Title - Sujet PERIMETER DETECTION SYSTEMS CCTV		
Solicitation No. - N° de l'invitation 21120-147874/A		Amendment No. - N° modif. 004
Client Reference No. - N° de référence du client 21120-14-2007874		Date 2014-07-07
GETS Reference No. - N° de référence de SEAG PW-\$\$HN-334-64960		
File No. - N° de dossier hn334.21120-147874	CCC No./N° CCC - FMS No./N° VME	
Solicitation Closes - L'invitation prend fin at - à 02:00 PM on - le 2014-07-25		Time Zone Fuseau horaire Eastern Standard Time EST
F.O.B. - F.A.B. Plant-Usine: <input type="checkbox"/> Destination: <input checked="" type="checkbox"/> Other-Autre: <input type="checkbox"/>		
Address Enquiries to: - Adresser toutes questions à: McLaughlin, Michael		Buyer Id - Id de l'acheteur hn334
Telephone No. - N° de téléphone (819) 956-3622 ()		FAX No. - N° de FAX () -
Destination - of Goods, Services, and Construction: Destination - des biens, services et construction:

**CORRECTIONAL SERVICES CANADA
TECHNICAL SERVICES BRANCH
ELECTRONIC SECURITY SYSTEMS**

ADDENDUM

**PWGSC File # 21120-147874
Replacement of Perimeter Cameras
For Use in Federal Correctional Institutions**

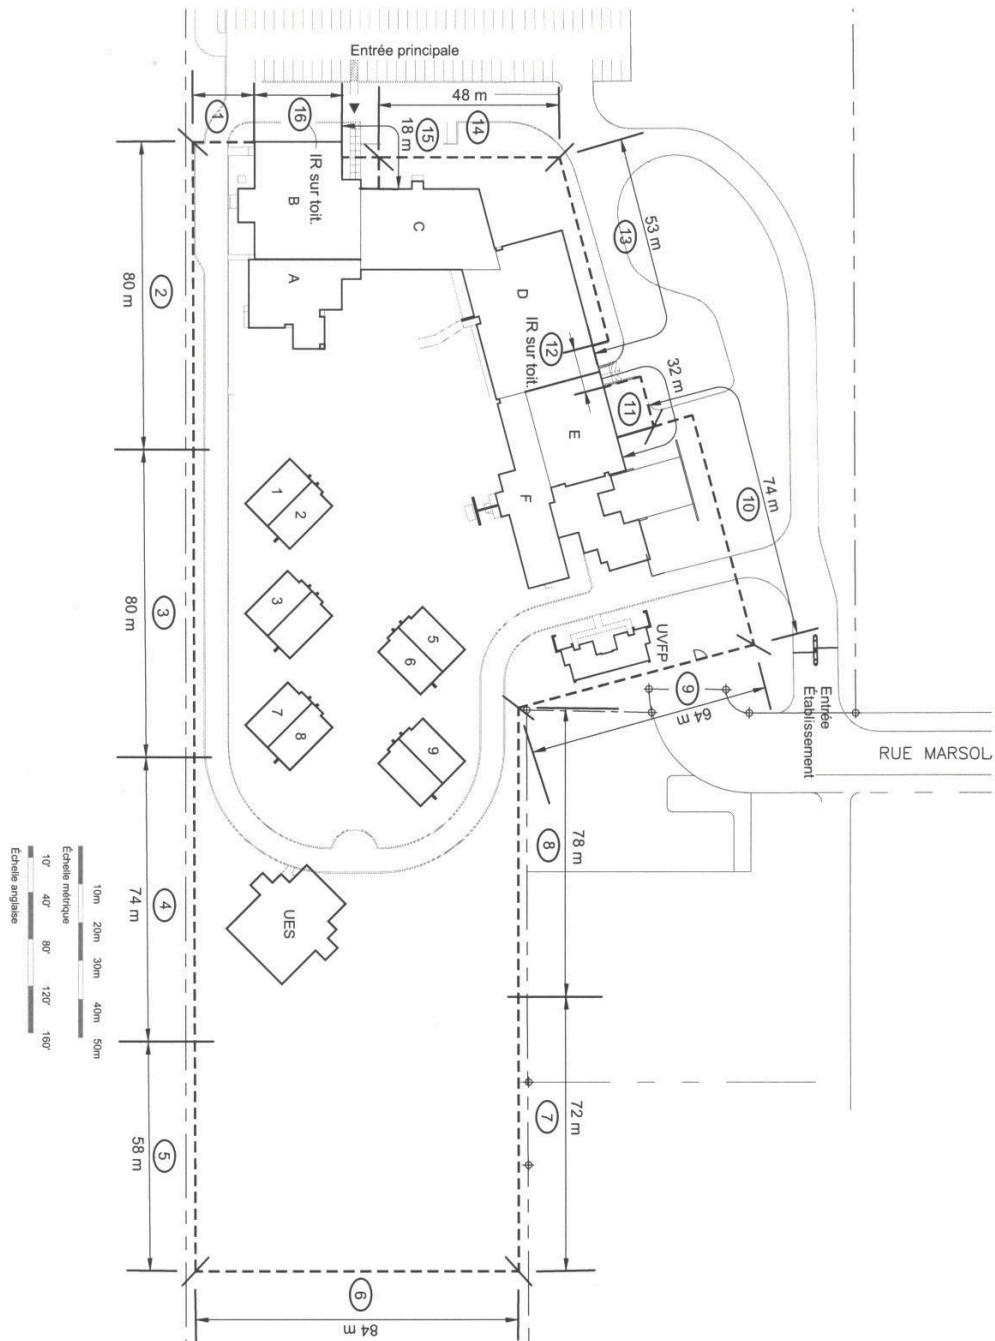
Fibre optics and perimeter enclosures

All video camera signals are currently carried directly to the CER by coaxial cables. These coaxial cables are located in underground conduits along the perimeter. The contractor will be responsible for removing the existing coaxial and supply cables for the existing cameras.

Two new 24-strand fibre optic cables must run from the CER; new conduits will have to be installed to take these optic fibres outside Building F to the perimeter fence near the "exterior-7 exit." The cable installed in the clockwise direction must be attached to the top of the perimeter fence. The cable installed in the counter clockwise direction must first be installed on the outside wall of buildings E and F using conduits before attaching it along the top of the perimeter fence.

Distances of 500 metres and 100 metres will be required for the perimeter fence in the clockwise and counter-clockwise directions respectively. Conduits will be required to bury the cable going clockwise under a 15-metre wide barrier. The fibre must be installed inside the fence and must be attached using UV-resistant fasteners.

A total of 4 perimeter enclosures will have to be installed on this fence (see section 4.16 for the enclosure specifications). Each of these enclosures will have to contain enough fibres for future expansion. Install conduits between the perimeter enclosure and the camera enclosures.

A total of ten (10) cameras will be connected to the new perimeter enclosures.

Eight (8) cameras will be installed on various buildings and their cabling will be inside the buildings:

- 4 cameras will be installed on Building B and will be located 150 metres from the CER;
- 1 camera will be installed on Building D and is located 50 metres from the CER;
- 3 cameras are installed on Building F and are 20 metres from the CER.

The drawings included in this package show the camera positions and the planned location of the cables and perimeter enclosures.
